Re: CPF 3-2021-5002

In response to the above-referenced Notice of Probable Violation, Proposed Civil Penalty and Proposed Compliance Order (NOPV) dated February 10, 2021, The operators, Enbridge Storage (Cushing), LLC; Enbridge Storage (Patoka), LLC; CCPS Transportation, LLC; and Illinois Extension Pipeline Company (collectively "Enbridge") attached the following documents:

Figure 1 Enbridge Bond with Magellan MP 421.2065

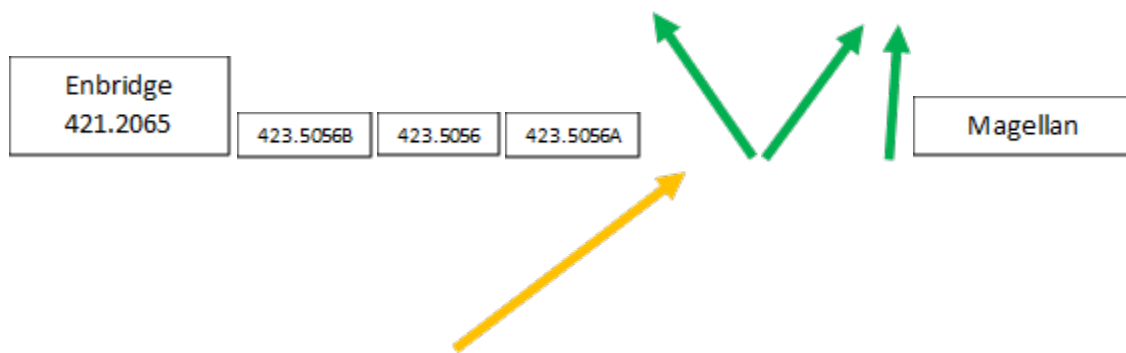
Bond current measurements at MP 423.5056, MP 423.5056A and 423.5056B were incorrectly identified as “Critical” bonds in the PCS database where Enbridge records cathodic protection data. These three locations should have been identified as “Informational” bonds as they are not interference bonds between Enbridge and Magellan, but are bonds tied into a common bus bar with Magellan. These three locations are current measurements between the three Magellan structures and read for informational purposes only.

There is one single bond tied into a common bus bar with the Magellan Lines 3, 4 and 5 at milepost 421.2065 that is currently identified as “Critical” and measurements recorded on at least on a bi-monthly basis. The bond is pictured below:

This bond is equipped with a remote monitoring unit that automatically records bond measurements on a scheduled basis. This bond was considered “critical” between 2017 and 2018 and bond measurements were recorded bi-monthly. Prior to 2017 the bond was not considered “critical” and only monitored at least annually.

Upon discovering this issue, the bonds at MP 423.5056, MP 423.5056A and 423.5056B were retired as “Critical” bonds. The correct bond for the Magellan foreign lines at MP 421.2065 is currently active and is being monitored as a “critical” bond with a remote monitoring unit.
